# CITY PLANNING COMMISSION

**APPLICATION:** Variance to reduce the side courtyard requirement from 10 feet to 5 feet 9 inches

**LOCATION:** 1310 Q Street

**APPLC. NO.** P87-293 **MEETING DATE.** August 13, 1987 **ITEM NO.** 21

**EXHIBIT A**  
**SITE PLAN**  
**FLOOR PLANS**

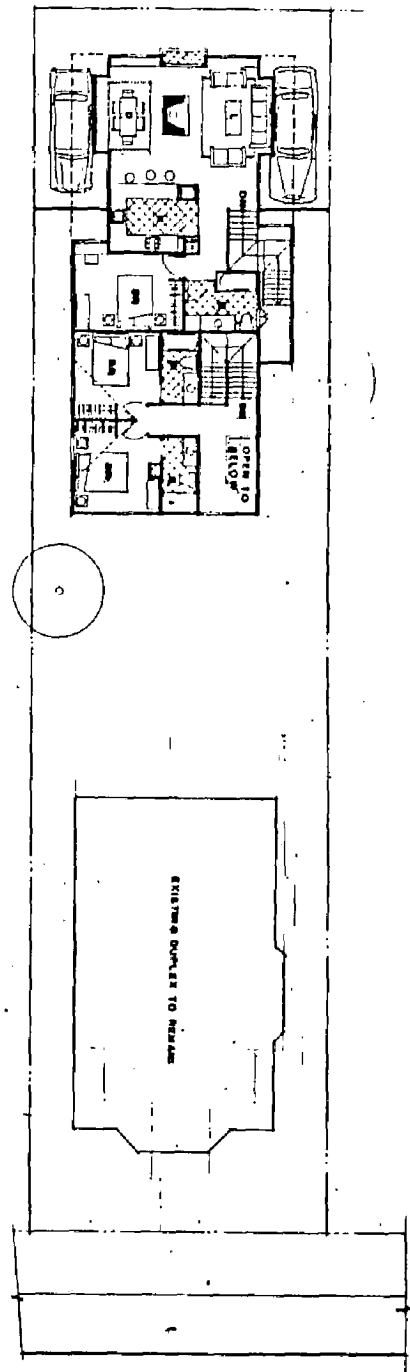
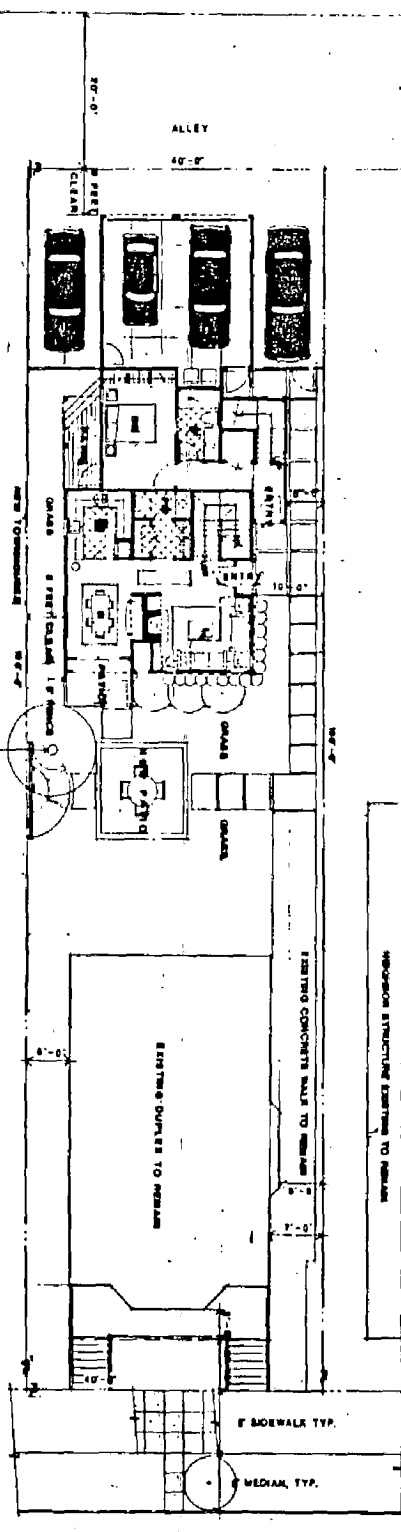
The applicant proposes to develop a two-story 1,310+ square foot duplex to the rear of the property. The distance between the existing structure and proposed structure would be 32 feet in order to provide a central yard area. Each of the two units is two level with two bedrooms/two bath. The main entrances are on the west elevation at ground level. The entrance of one unit faces north and does not require a 10 foot courtyard setback. The other entrance faces west and the 10 foot required courtyard setback is provided. Access from Q Street to the new duplex would be along the existing sideyard setback (five feet, nine inches) of the existing structure. Therefore, the purpose of the variance request is to reduce the 10 foot setback requirement to five feet, nine inches.

An attached two car garage is proposed nearest the rear of the property with access from the alley. A recessed area for laundry facilities are provided in the garage. Two parking pads are shown to either side of the garage for use by tenants of the existing duplex. The garage and parking pads are setback six feet from the alley.

The proposed project will not be intrusive to adjacent properties as it is nine feet behind the two story four-plex to the east and 17 feet behind the two story apartment to the west. Also, a number of trees will help to visually buffer adjacent properties.

1. For security purposes, garage doors shall be of a durable material with interior locking devices. The doors must have a six inch wide horizontal design to match the siding.
2. A six foot high fence with locking gates shall be provided between the parking area and building.
3. The parking area walkways should be well lit.
4. Landscaping should be provided in the yard area between the existing and proposed duplexes.

1. Approve the variance to reduce the 10 foot courtyard requirement to five feet 9 inches subject to conditions and based upon Findings of Fact which follow:
  - a. The garage doors and fence gates shall be secured with locks.
  - b. Landscaping and irrigation plans are to be submitted to the Design Review Preservation Board prior to issuance of building permits.
  - c. The project shall be reviewed and approved by the Design Review/Preservation Board prior to issuance of building permits/

**EXHIBIT B**  
**ELEVATIONS**

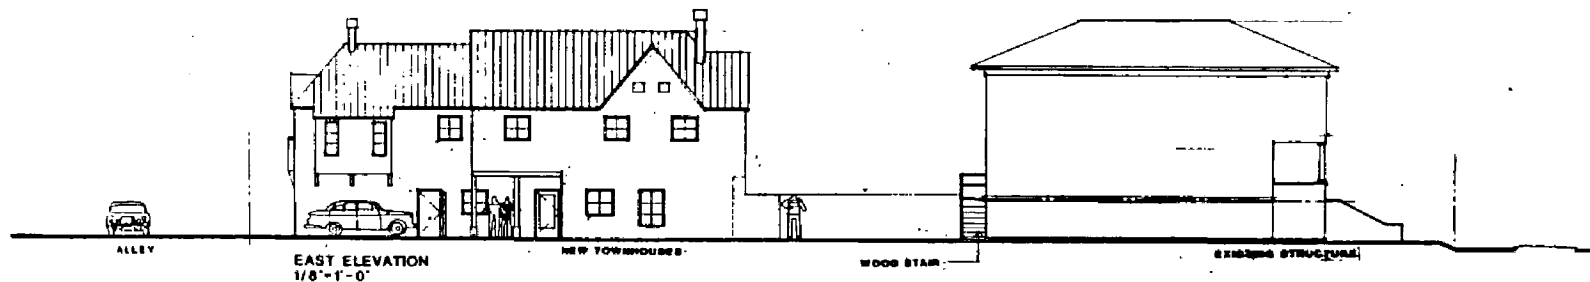
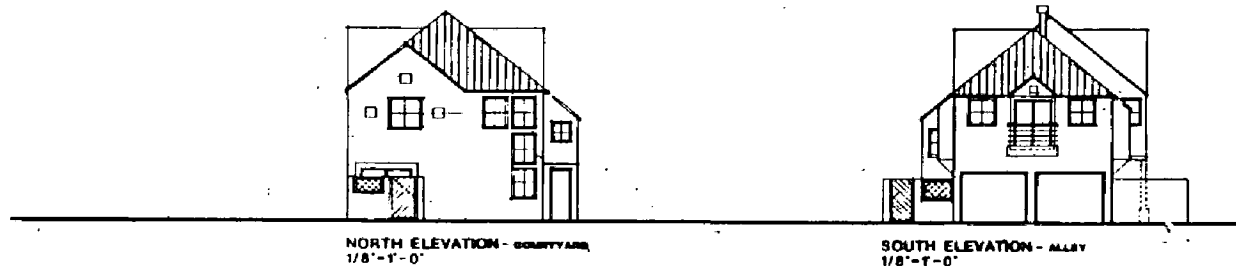
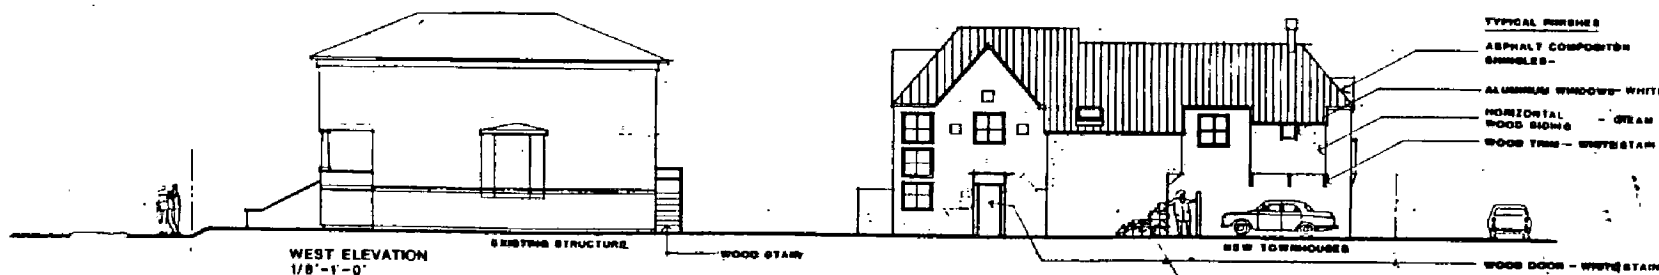
The applicant proposes to use six inch wide horizontal wood siding on all elevations. The existing structure on-site has narrow two inch wide wood siding. Although the siding of the two structures are different, staff finds the proposed siding acceptable as the two structures cannot be viewed together from Q Street or 13th Street. Also, adjacent structures have a minimum horizontal siding width of

The varied roof design and recessed wall areas provide an interesting and acceptable design. Staff recommends that the proposed aluminum windows have a baked in enamel finish. Roof equipment, if applicable, will be reviewed by the Design Review/Preservation Board. Preliminary comments prior to Preservation Board review include the following:
